To/Attention	Alicia Clark	Date	December 12, 2014
From	Dan Hess	Project	Russell MP Room
cc	Gordon Odette, Scott Wood	Project No.	12004
Subject	Warranty List

WARRANTY INSPECTION

PROJECT:	PARKROSE SCHOOL DISTRICT / SHAVER ELEMENTARY SCHOOL ROOF REPLACEMENT PROJECT - Q.C. INSPECTIONS	PROJECT #: R2817.08
-----------------	--	----------------------------

PROJECT:	PARKROSE SD / SACRAMENTO ELEMENTARY SCHOOL ROOF REPLACEMENT PROJECT - Q. C. INSPECTIONS	PROJECT #: R2817.07
-----------------	--	----------------------------

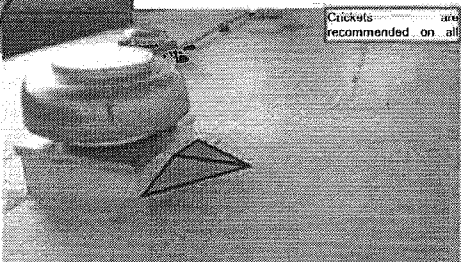
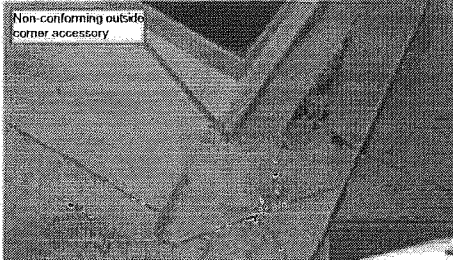
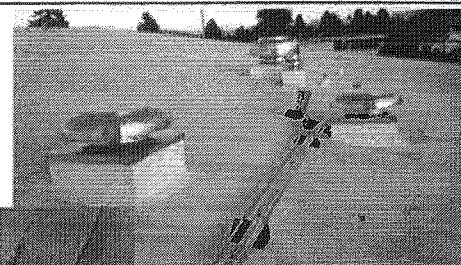
- 1.01 Three new exhaust fans have been installed through the new Sarnafil roof system on the South slope of Roof Area A. The three curbs have been installed with crickets to promote positive drainage. The outside corners of these units have been flashed with field fabricated flashing in lieu of the pre-molded accessories as was specified in the 2013 Roof Replacement project Contract Documents. It is of additional concern that these tenant improvement may not have been performed by the same installing contractor of 2013. This inconsistency of roofing contractors could have disrupted the installing contractor's warranty, as now a second contractor has performed work on the warranted roof. As well, if the roofing manufacturer's was not contacted prior to the installation of these tenant improvements, the manufacturer's warranty may also be disrupted.

Non-conforming outside corner accessory

Recommendation: Review the 2014 Contract Documents to confirm compliance to the Roofing Specification regarding the membrane installation at each new curb. Notify the roofing manufacturer in writing of the tenant improvements, their location on the roof plan and information regarding the installing contractor, in effort to maintain the existing warranty. It should be verified that the installing contractor of these tenant improvements is an authorized Sarnafil installer, if not the curb should be re-flashed by an authorized Sarnafil installer and preferably by the original installing contractor of the roof system.

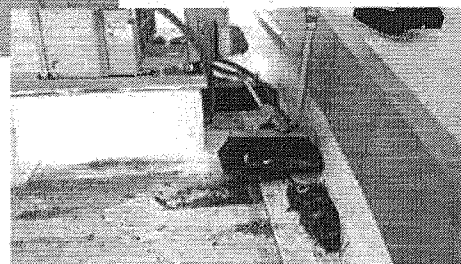
- 1.02 Due to the location of one of the newly installed curbs, the condensate line, which traverses the roof, is askew from its original straight line. This has resulted in the pipe being stressed at the corner of the curb to make the turn into the flashing hood. Additionally, the other end of this line was pushed up slope to help account for the new angle, which in turn, has lifted the support block off the roof surface of Roof Area B. By lifting the support block off the roof surface, the block is now in contact with the base flashing membrane, which could result in friction wear of the base flashing and ultimately water intrusion into the structure.

Recommendation: This line should be refabricated to account for all changes in direction and length to avoid stress in the line and to place the pipe support back to the roof surface.

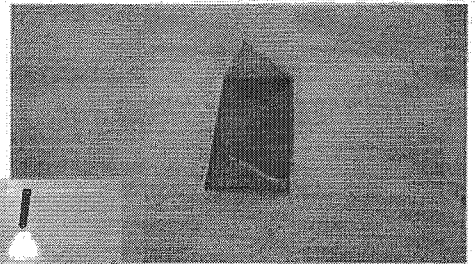
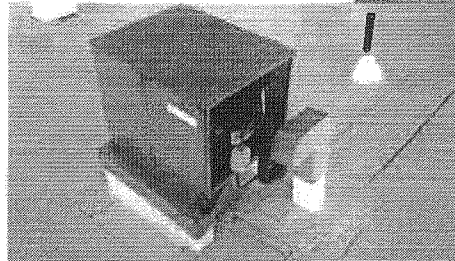
- 1.04 The hood to a refrigerant unit has become dislodged and was found on the membrane. Sharp edges of the hood could have resulted in damage to the membrane, though none was observed during this inspection.

Recommendation: Reattach the hood to the unit with securement fasteners or if no longer necessary, remove the hood from the roof level.

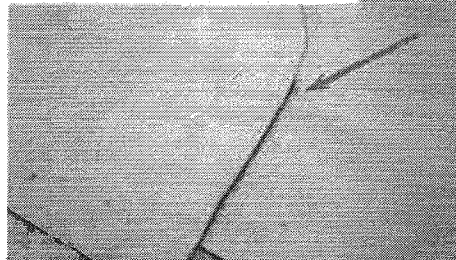
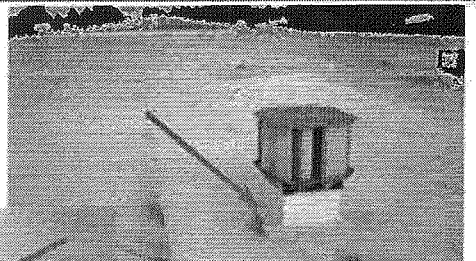
- 1.05 On the unit depicted to the right, one outside corner was installed with a minor void in the weld at the transition, which over time could continue to open resulting in a moisture intrusion.

Recommendation: Install a fully welded patch of unsupported membrane over the damage in accordance with the manufacturer's written repair procedures.

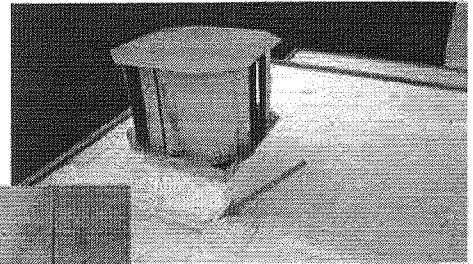
- 1.06 On the unit depicted to the right, one outside corner was installed with a minor void in the weld at the transition, which over time could continue to open resulting in a moisture intrusion.

Recommendation: Install a fully welded patch of unsupported membrane over the damage in accordance with the manufacturer's written repair procedures

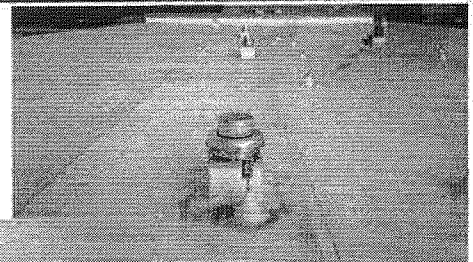
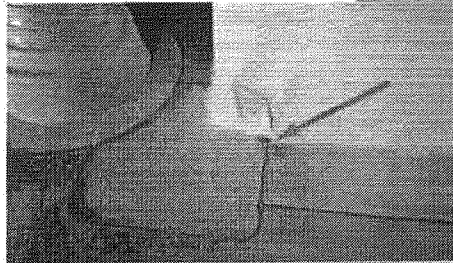
- 1.07 On the unit depicted to the right, one outside corner was installed and pressed in with a tool at the transition which has resulted in damage to the unsupported membrane. Though this damage may not yet be a source of moisture intrusion, these conditions have history of becoming leak sources.

Recommendation: Install a fully welded patch of unsupported membrane over the damage in accordance with the manufacturer's written repair procedures.

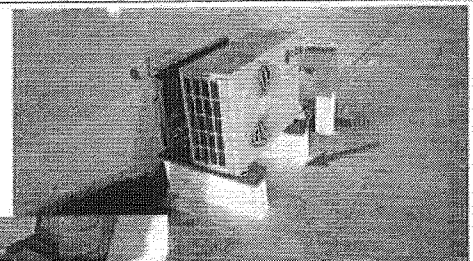
- 1.08 On Roof Area C, at the location of the elevated Condenser unit, one outside corner flashing was installed with a hole in the membrane. This is often the result of an over stretched membrane and could result in moisture intrusion into the roof system and ultimately the structure as a leak.

Recommendation: Install a fully welded membrane patch of unsupported PVC over the damaged location in accordance with the manufacturer's written repair

procedures.

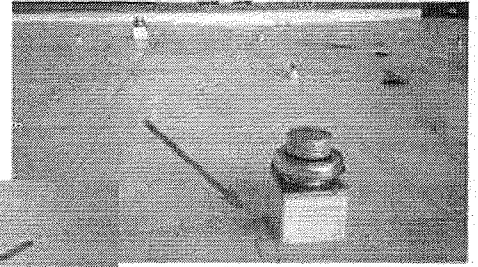
- 1.09 On the unit depicted to the right, one outside corner was installed with a minor void in the weld at the transition, which over time could continue to open resulting in a moisture intrusion.

Recommendation: Install a fully welded patch of unsupported membrane over the damage in accordance with the manufacturer's written repair procedures.

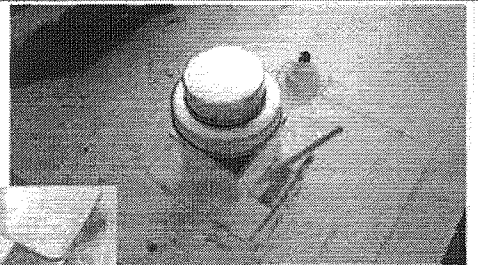
- 1.10 On the unit depicted to the right, one outside corner was installed with damage of the outside corner at the transition, which over time could result in a moisture intrusion.

Recommendation: Install a fully welded patch of unsupported membrane over the damaged area in accordance with the manufacturer's written repair procedures

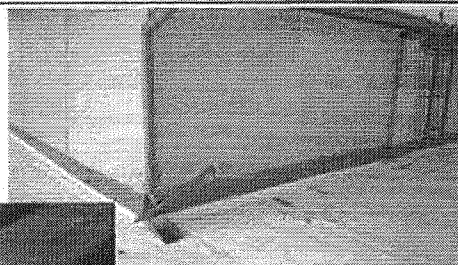
- 1.02 The outside corner patch at the base flashing on Roof Area B, adjacent to the corner down spout was installed with a cold weld, which is allowing moisture to infiltrate between the membranes, which will result in leaks if not addressed.

Recommendation: Install a fully welded patch of unsupported membrane over the damage in accordance with the manufacturer's written repair procedures.

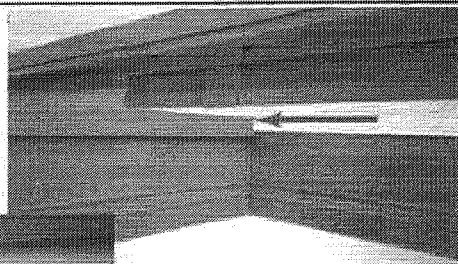
- 1.03 At the inside corner of the clad metal flashing, an unsupported membrane corner patch has become disbonded from the clad metal and could result in moisture intrusion.

Recommendation: Install a fully welded patch of unsupported membrane over the damage in accordance with the manufacturer's written repair procedures.

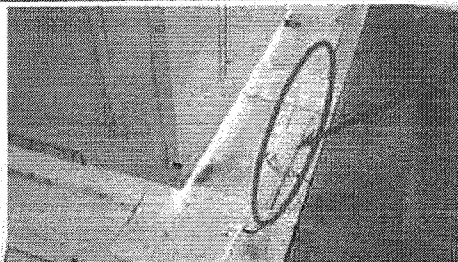
- 1.04 On the south side of the HVAC unit, the base flashing membrane has become disbonded and is open to moisture intrusion. This location was previously marked for repair by the manufacturer's technical representative.

Recommendation: Install a fully welded patch of Sarnafil's G410 membrane over the damage in accordance with the manufacturer's written repair procedures.
